CITY PLAN COMMISSION**THURSDAY, APRIL 10, 2025****FILE NUMBER:** S245-060R**SENIOR PLANNER:** Hema Sharma**LOCATION:** Spruce Valley Lane, south of Pentagon Parkway**DATE FILED:** March 12, 2025**ZONING:** R-7.5(A)**CITY COUNCIL DISTRICT:** 3**SIZE OF REQUEST:** 1.107-acres**APPLICANT/OWNER:** Richard Stauffer, City of Dallas

REQUEST: An application to revise a previously approved plat (S245-060) to create one 1.017-acre lot from a tract of land in City Block 6979 and to dedicate right-of-way on property located on Spruce Valley Lane, south of Pentagon Parkway.

S245-060R

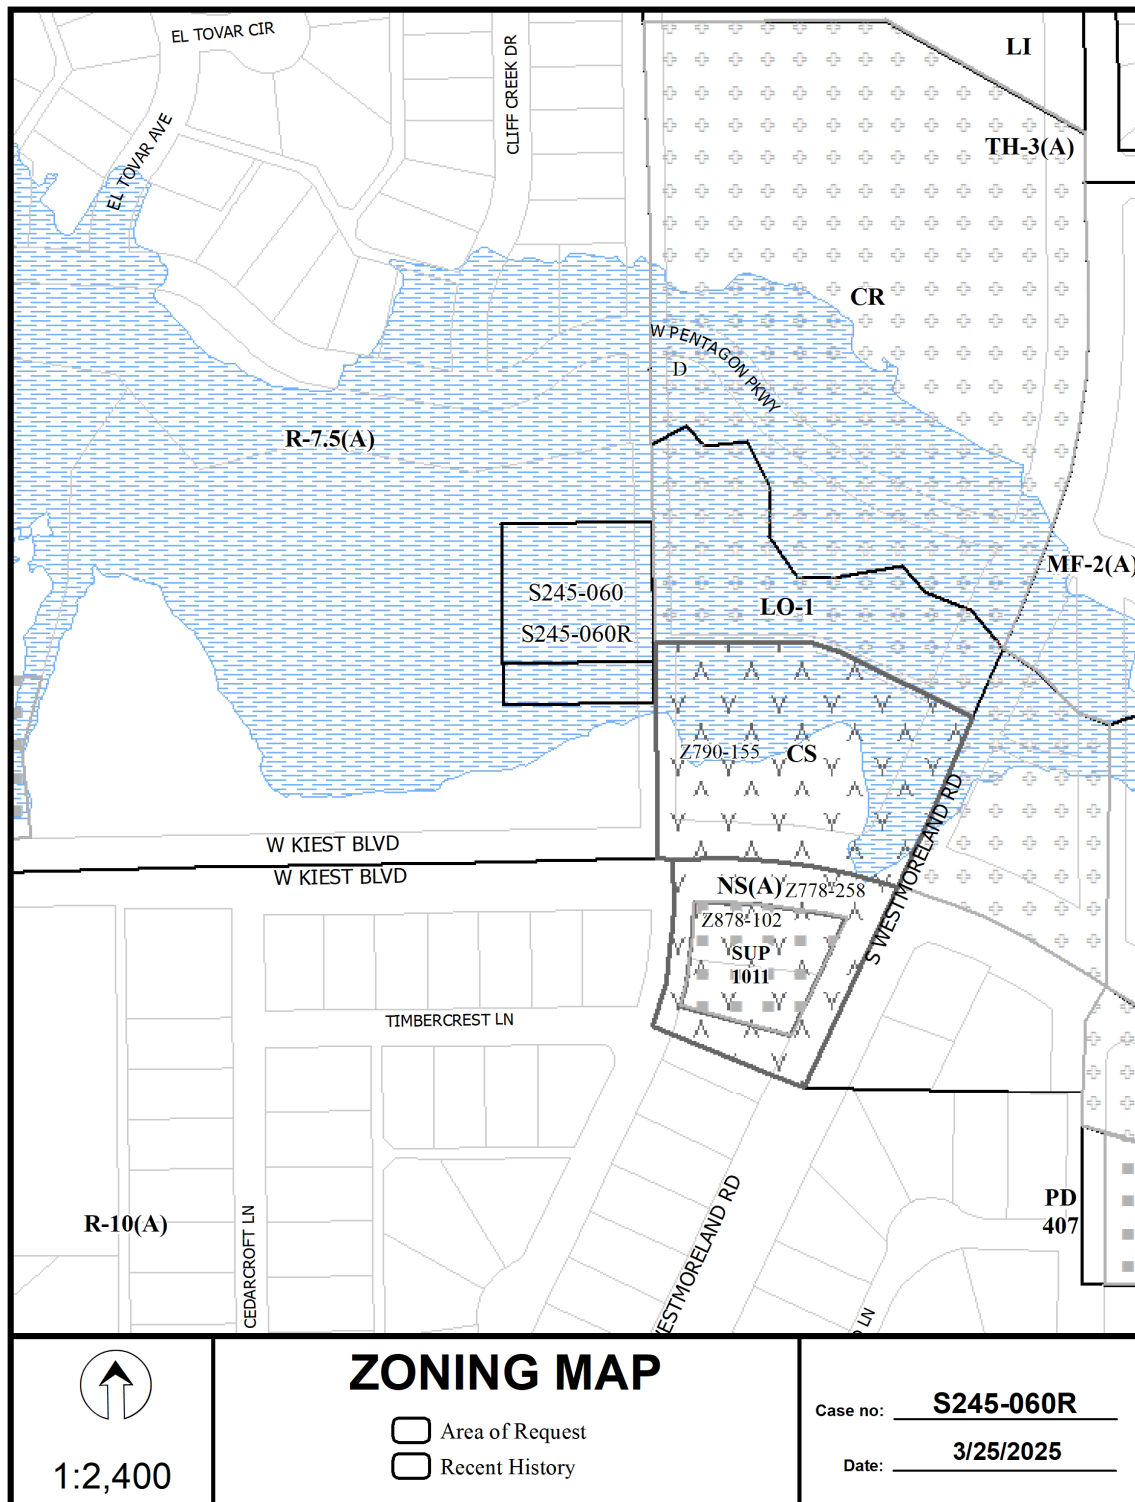
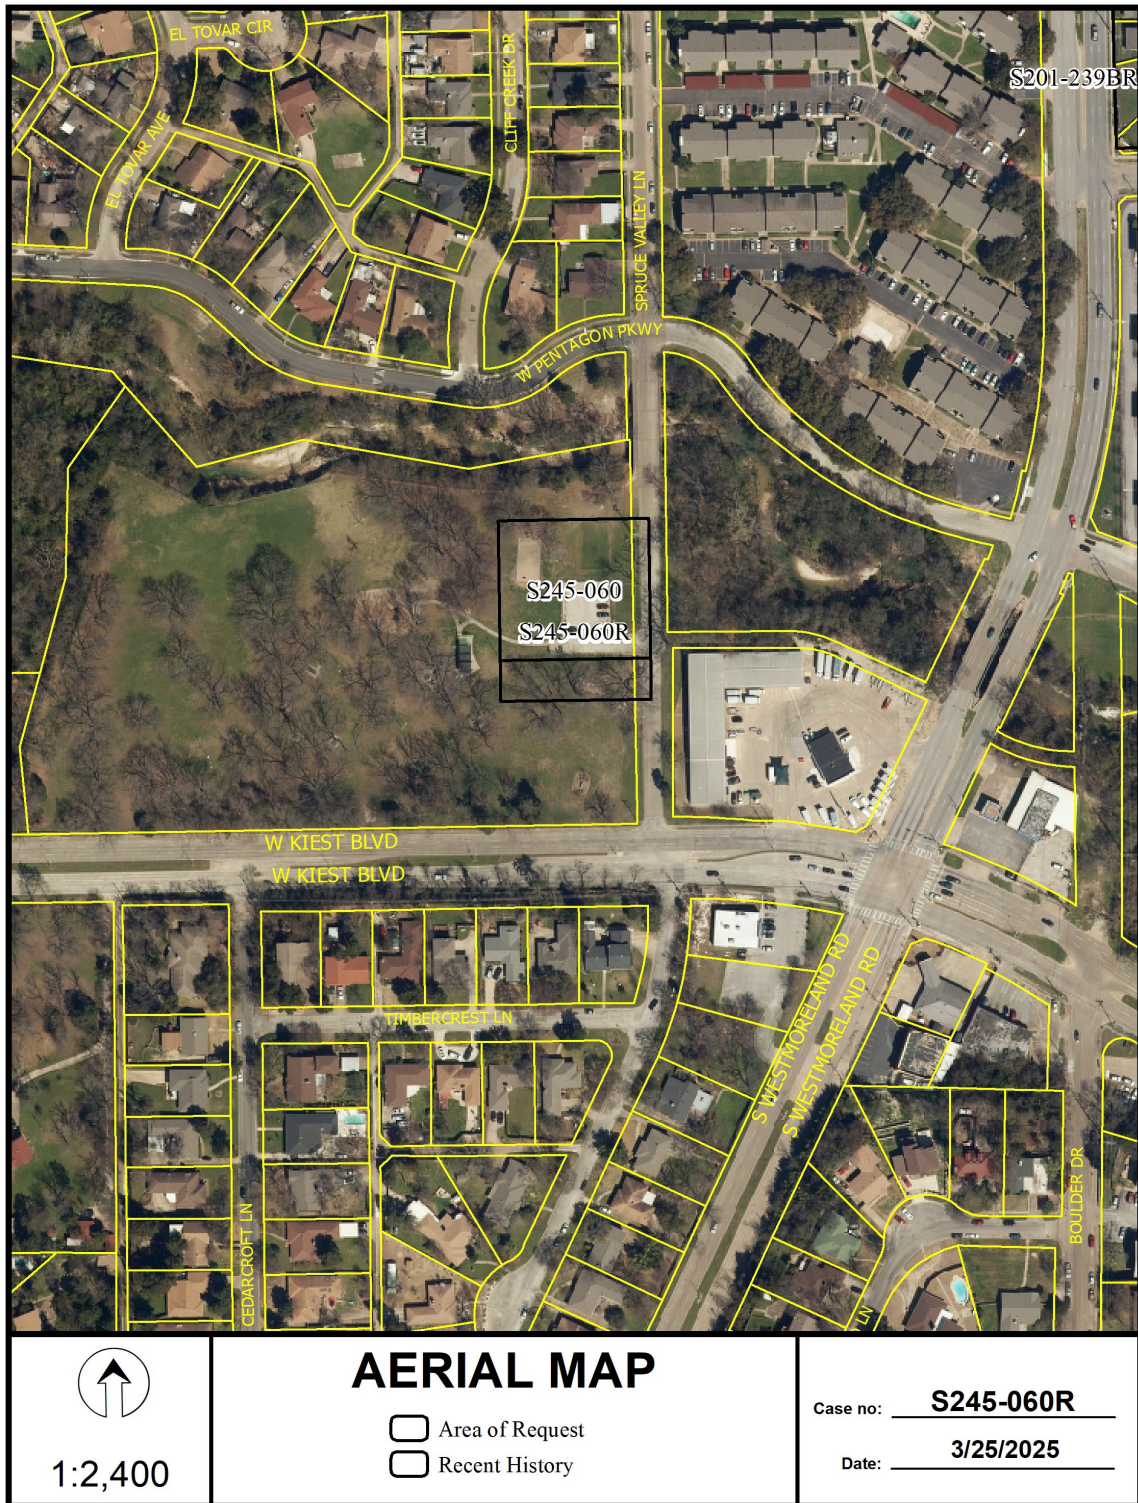
15. On the final plat, dedicate 28 feet of right-of-way (via fee simple or street easement) from the established centerline of Spruce Valley Lane. *Sections 51A-8.602(c), 51A-8.604(c) and 51A-8.611(c).*

23. Prior to final plat, submit a completed final plat checklist and all supporting documents.
24. On the final plat, show how all adjoining right-of-way was created. Section 51A-8.403(a)(1)(A)(xxii).
25. On the final plat, show distances/width across all adjoining right-of-way. Platting Guidelines.
26. On the final plat, show recording information on all existing easements within 150 feet of the property.
27. On the final plat, show all additions or tracts of land within 150 feet of the property with recording information. Platting Guidelines.
28. On the final plat, need new/different plat name.

33. On the final plat, change "W. Pentagon Parkway" to "Pentagon Parkway".
Section 51A-8.403(a)(1)(A)(xii).
34. On the final plat, identify the property as Lot 1 in City Block 1/6979.
